**Planning Department
Transportation Development Services**

**Re: Las Lomas Assisted Living
1331 Cuesta Abajo
Traffic Circulation Layout – Revised and Phasing Plan
Engineer's/Architect's Stamp dated 6-10-15 (D16-D101)**

Based upon the information provided in your submittal received 6-10-15, the above referenced plan cannot be approved for Building Permit until the following comments are addressed:

Phasing Plan

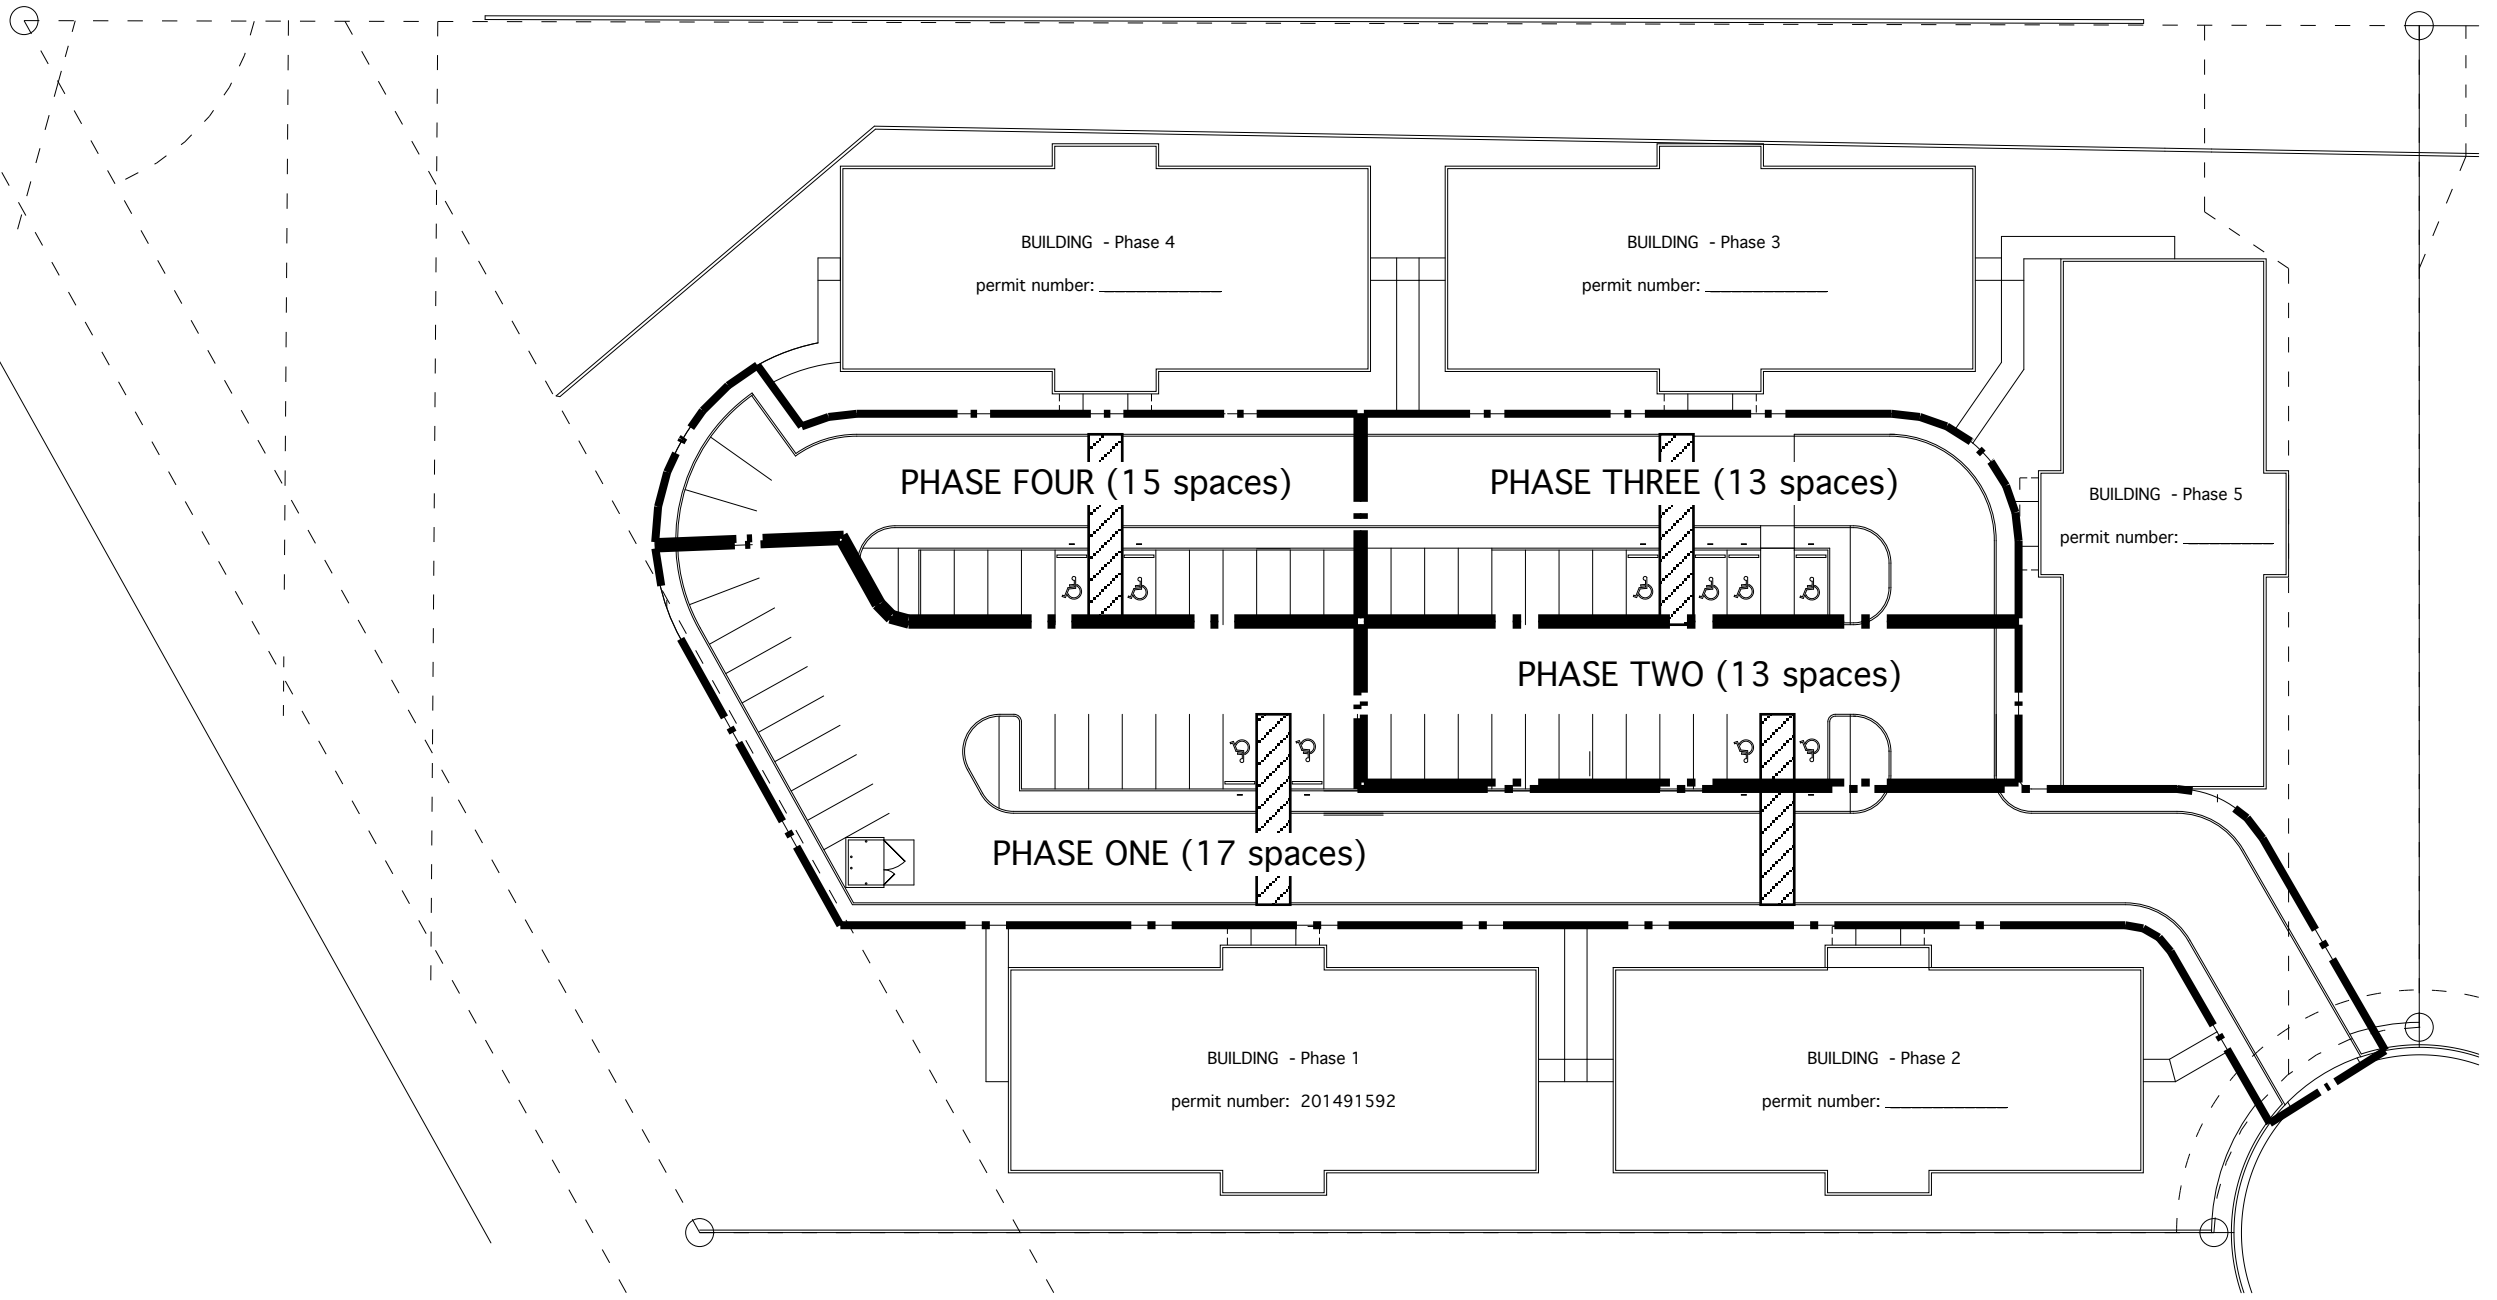
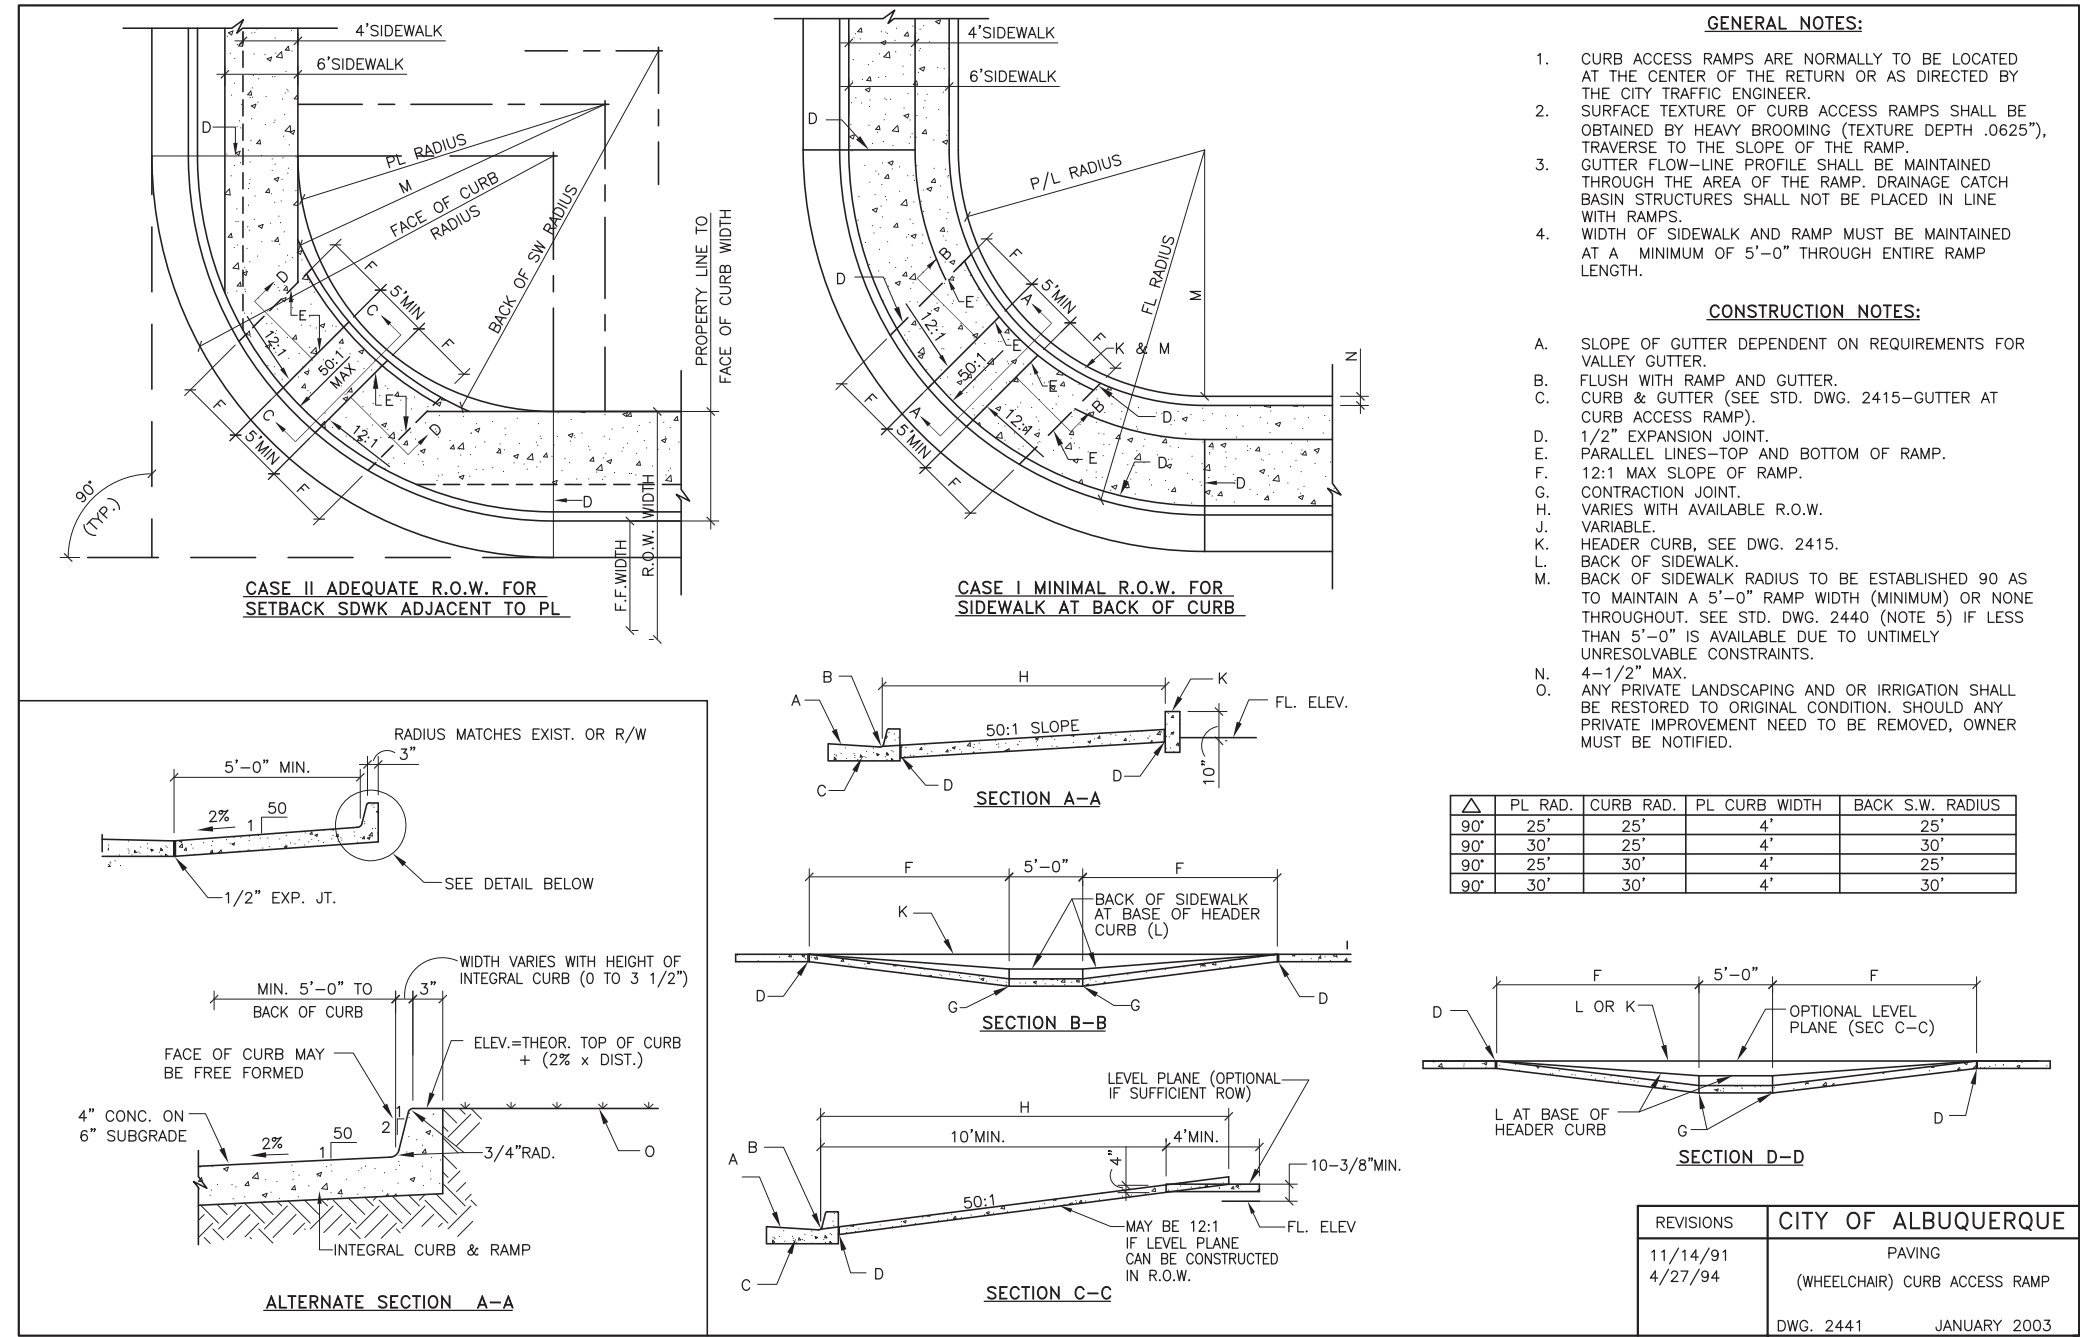
6. Show all drive aisle widths and radii. Per Fire Department, the turning radii for emergency vehicles must be a minimal of 28 Ft. It appears that the radius at the north end of the parking lot and the radii at the south drive pad entrance do not meet the Fire Department requirements. Please provide details of drive path turn around and south drive pad entrance, listing all radii.

Enlarged Site Plan

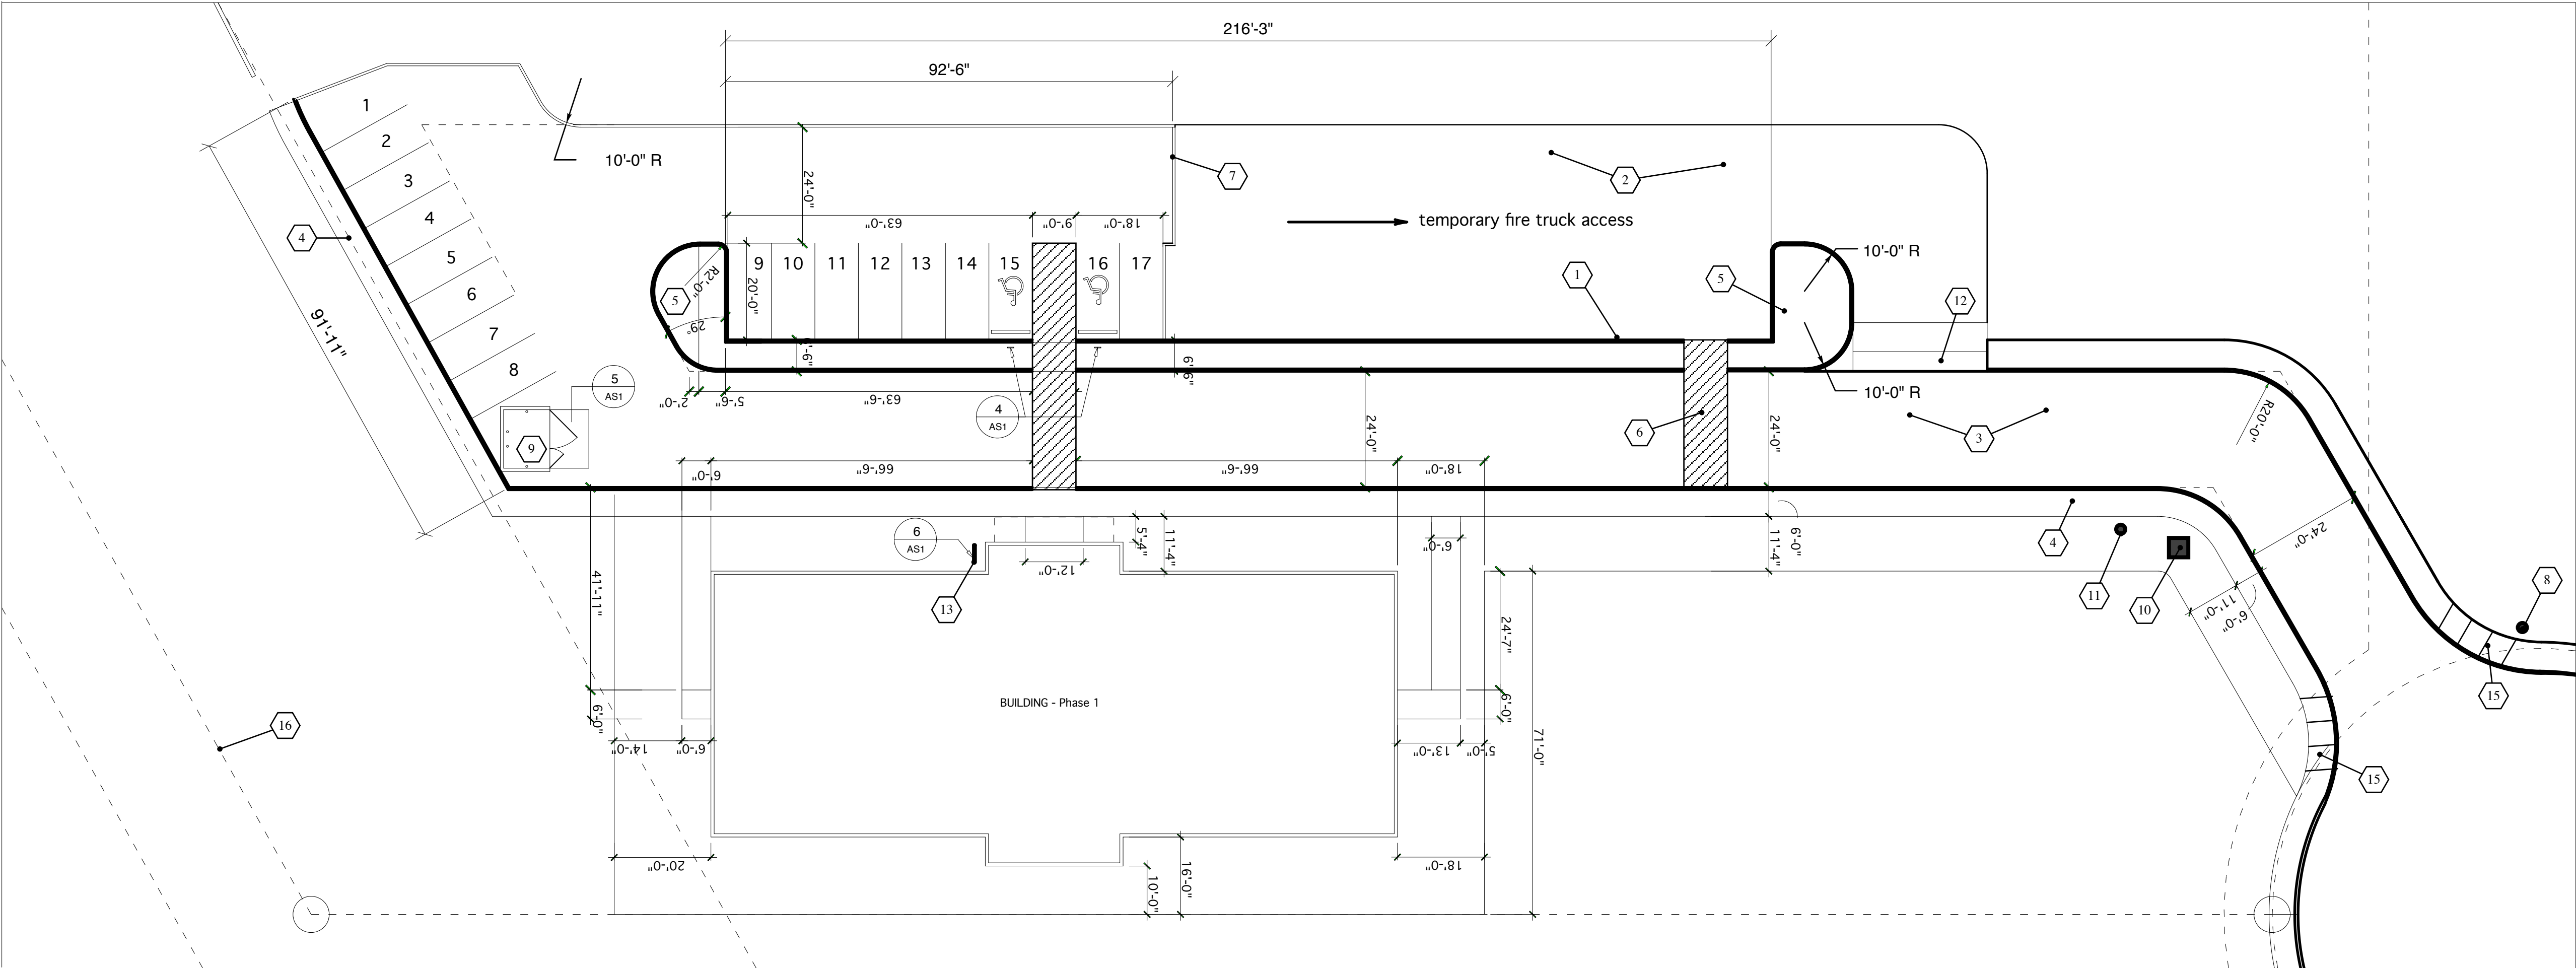
1. Please identify all doors, structures, sidewalks, curbs, drive pads, walls and anything that influences the parking and circulation on the site.
2. Please provide more detail on grades and slopes in the parking area and/ or the handicap accessible parking areas and the ADA pedestrian walk way.

3. Please provide a Legend showing line types.
4. The ADA van accessible sign must have the required language per 66-7-352.4C NMSA 1978 **"Violators Are Subject to a Fine and/or Towing."**

5. The ADA access aisle shall have the words **"NO PARKING"** in capital letters, each of which shall be at least one foot high and at least two inches wide, placed at the rear of the parking space so as to be close to where an adjacent vehicle's rear tire would be placed. (66-1-4.1.B NMSA 1978)

7. For passenger vehicles, the minimum end island radius is 15 feet. Landscape island radius for delivery trucks is 25 feet or larger. Please label all radii.

8. A five-foot keyway is required for dead-end parking aisles. The north end of the parking lot at space labeled No. "1" will require a 5 Ft. turn out, so that vehicles may have adequate room to back out and exit.

9. Please specify the City Standard Drawing Numbers when applicable.
10. Provide a min 6" or max 8" high concrete barrier curb or other acceptable barrier between landscaping and parking areas and/or drive aisles. Please identify curb barriers.
11. Please include two copies of the traffic circulation layout at the next submittal. Please also include Sheet No. 2 with missing details on bicycle parking, curb barriers, side walk and ADA signage.
